Research Reactor Center

Reference: Docket 50-186  
University of Missouri – Columbia Research Reactor  
Amended Facility License R-103

SUBJECT: Written communication as specified by 10 CFR 50.4(b)(1) requesting U.S. Nuclear Regulatory Commission approval to amend the Technical Specifications appended to Facility License R-103 pursuant to 10 CFR 50.59(c) and 10 CFR 50.90

Figure 6.0

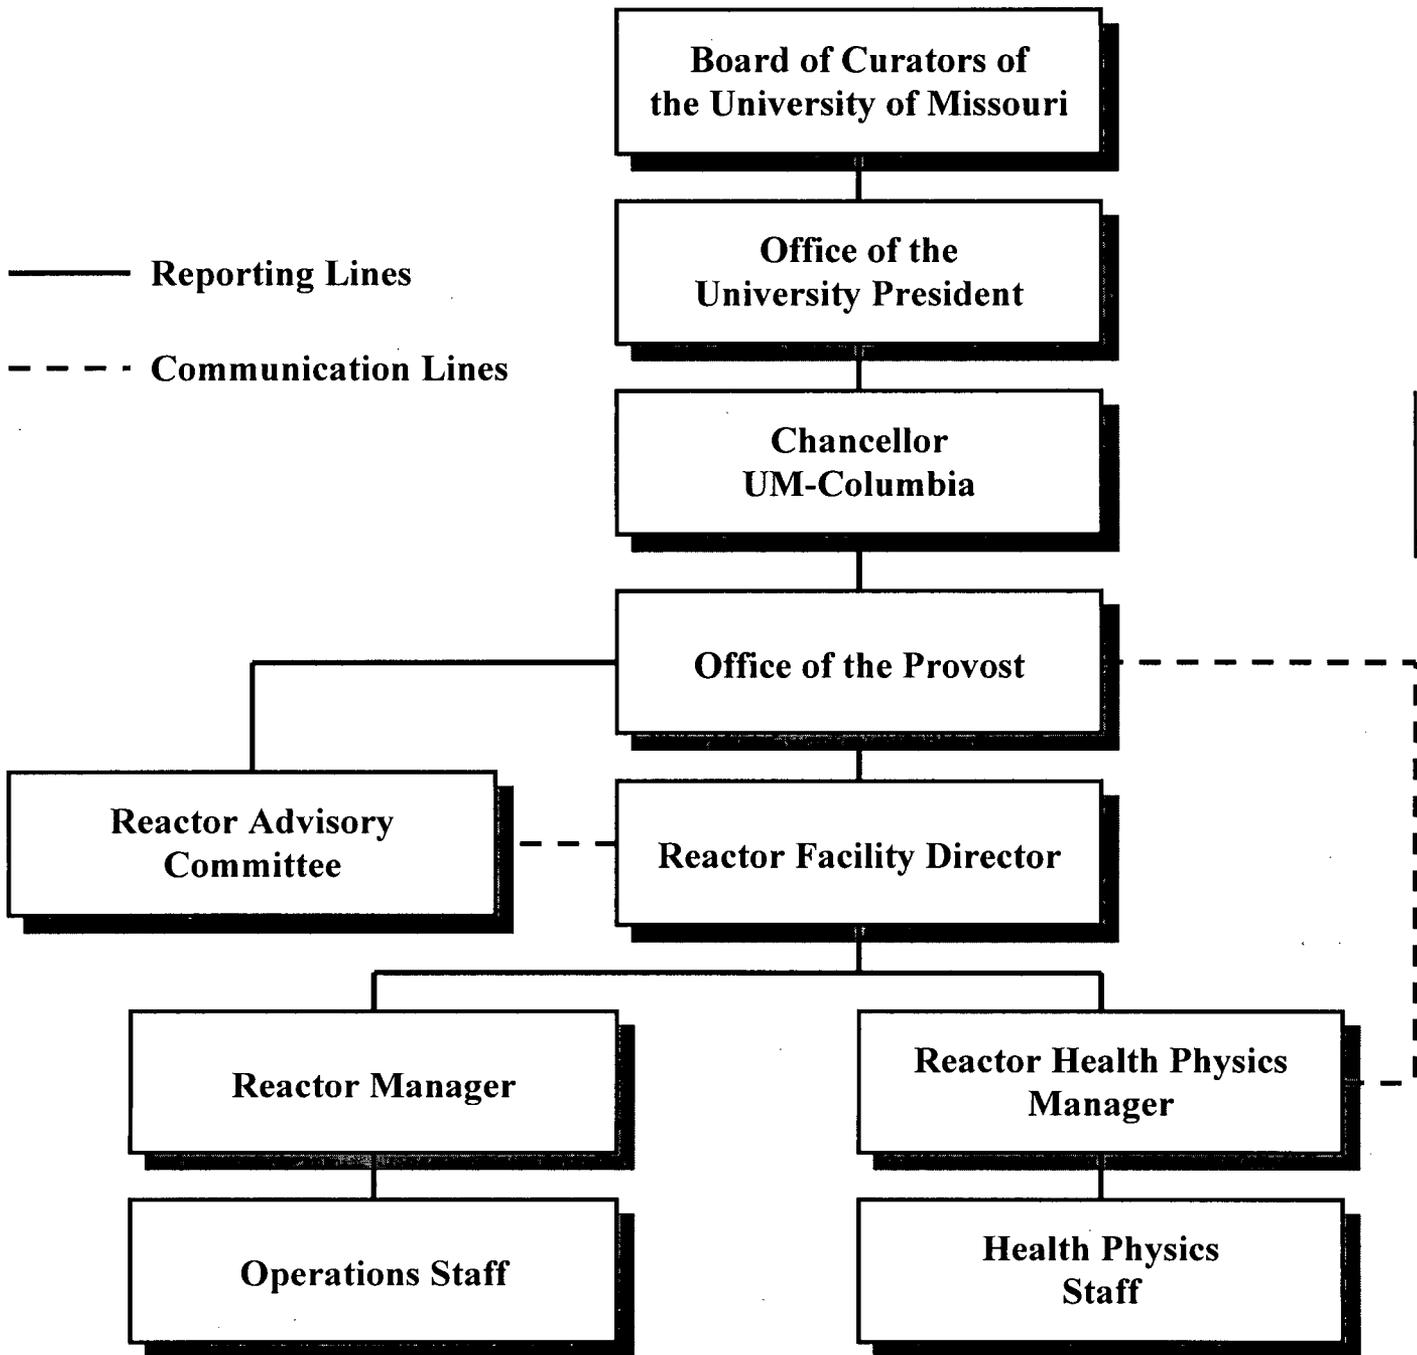
The University of Missouri Research Reactor (MURR) is requesting a change to the facility Technical Specifications (TSs) that modifies the organization for the management and operation of the reactor by re-inserting the Office of the Chancellor in Section 6.0 of the MURR TSs as the primary University official responsible for its activities.

Attached is the TS page that will implement the requested change. If there are questions regarding this request, please contact me at (573) 882-5276. I declare under penalty of perjury that the foregoing is true and correct.
